Service Bulletin

S.B. No: 130

Title: INSPECTION OF RUDDER PEDALS FOR ADJUSTMENT RESTRICTION

Fig 1
VIEW ON RUDDER PEDAL SLIDER HOUSING

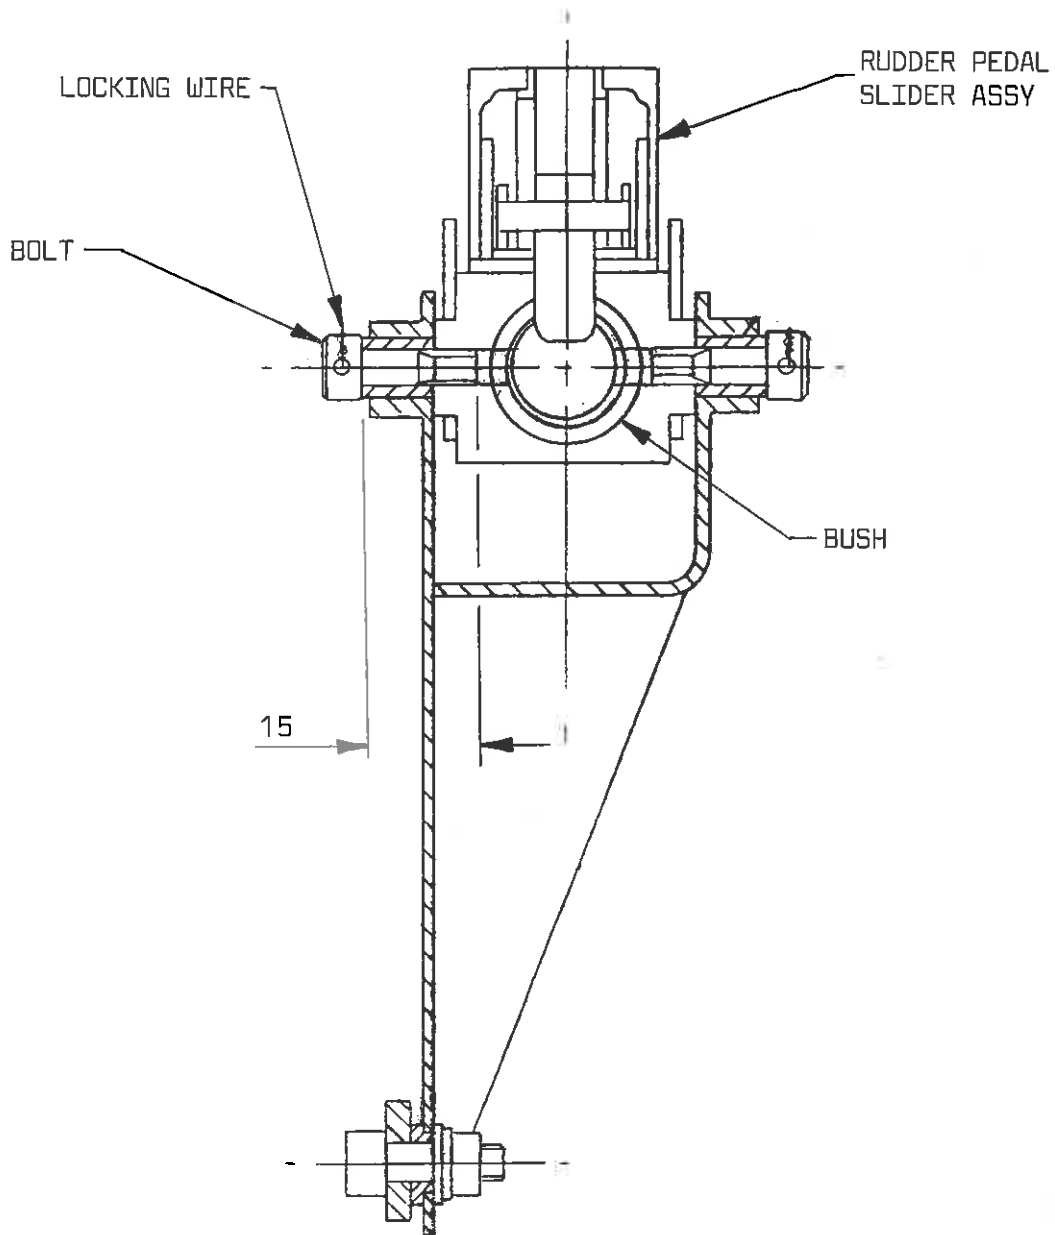
A case has been reported of the pivot bolt fouling the rudder pedal slider assembly, preventing proper adjustment.

1. Inspect the rudder pedal assembly and check for full, free and smooth movement of adjustment slider.
2. If slider movement is restricted or appears stiff, inspect slider bush and pivot bolts for any visual signs of fouling, ref. Fig. 1.
3. If fouling occurs, adopt the following procedure:
 - i) Remove bolt or bolts that are fouling and shorten them by 1mm to give a nominal length of 15mm measured from the underside of the bolt head. Etch prime the cut face of the bolt. Re-identify bolt in IPC as T67B-08-537.
 - ii) Ream out internal diameter of bush to 16.00 +.05/-0 mm to remove any deformation caused by fouling.
 - iii) Replace shortened bolt T67B-08-537 and renew locking wire.
4. Alternatively, invoke Mod M808 to replace all pivot bolts.
5. Annotate logbook "SB 130 complied with".
